Access Compliance Report

Public Rights-of-Way

(Curb Ramps)

Intersection ID: 20177	Main Street: FAIRVIEW_RD	Cross Street: OGLUKIAN_RD	Location: SW
ADA ID: F2D8640E4354	Ramp Type: PerpDiag	Initial Pass/Fail: Fail	Overall Compliance: No
		Severity Score: 12.5

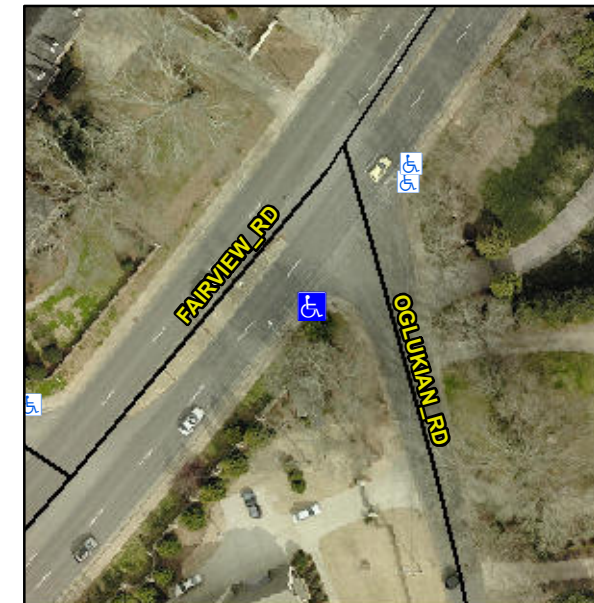
Not Found, R304.5.3

Compliance	Description	Data	Compliance	Description	Data
N/A	Ramp Length (in)	62.0	Yes	Ramp Slope (%)	6.9
Yes	Ramp Width (in)	48.0	No	Ramp XSlope (%)	5.8
N/A	Flare Type LT	N/A	N/A	Flare Type RT	N/A
N/A	Flare Slope LT (%)	N/A	N/A	Flare Slope RT (%)	N/A
N/A	Flare Traversable LT?	N/A	N/A	Flare Traversable RT?	N/A
N/A	Landing Length (in)	N/A	N/A	DWS Provided?	N/A
N/A	Landing Width (in)	N/A	N/A	DWS Contrast?	N/A
N/A	Landing Slope (%)	N/A	N/A	DWS Length (in)	N/A
N/A	Landing X Slope (%)	N/A	N/A	DWS Full Width?	N/A
N/A	Landing Curb? (Y/N)	N/A	N/A	DWS Offset (in)	N/A
N/A	Shared Landing?	N/A			
N/A	Gutter Ponding?	N/A	N/A	Gutter Slope (%)	N/A
N/A	Gutter Lip Ht (in)	N/A	N/A	Gutter X Slope (%)	N/A
N/A	Painted X Walk1?	No	N/A	Painted X Walk2?	No
	X Walk 1 Direction	To NE		X Walk 2 Direction	To NW
N/A	X Walk 1 Width (in)	N/A	N/A	X Walk 2 Width (in)	N/A
	X Walk 1 Slope (%)	8.1		X Walk 2 Slope (%)	7.4
	X Walk 1 X Slope (%)	2.7		X Walk 2 X Slope (%)	5.6

Remove & Replace Curb Ramp With Two New Directional Ramps or Equivalent.
